**New recommendation for grinding angle of exhaust valve spindle**

SL2019-682/JAG  
October 2019

Owners and operators of MAN B&W two-stroke marine diesel engines.  
Type: All 30-98 bore engines

**“Wide seat” bottom piece designs**

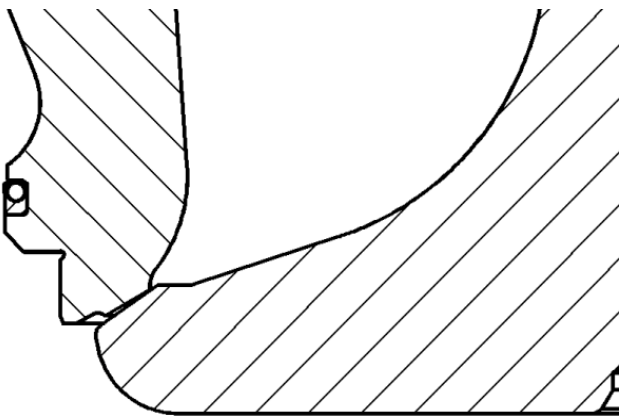
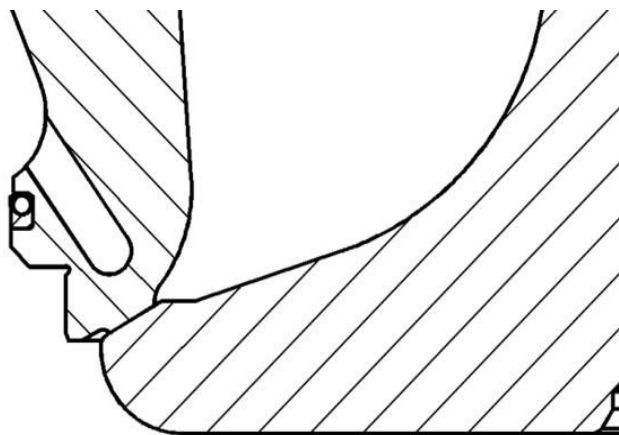
However, service inspections have shown that the predominant contact pattern between spindle seat and bottom piece seat is an inner contact rather than near full contact as intended.

These observations have led us to update the machining tolerances on spindle seat angle for a better parallel contact between the two seats, which will improve the heat transfer between the bottom piece and the spindle. Today, the updated seat angle tolerances are the new standard for all new spindles purchased, but for the first recondition of spindles in service we recommend to apply the new spindle seat angle, as also described in your maintenance document Work Card 2265-0200 or for older manuals M90802.

**New grinding angle for spindle seat 30.2° +0.05/-0**

Note: this applies to spindles serviced in bottom pieces of both W-seat and wide-seat designs. The seat angle for the bottom piece keeps the 30 degree but with new tolerance 30.0° +0/- 0.05.
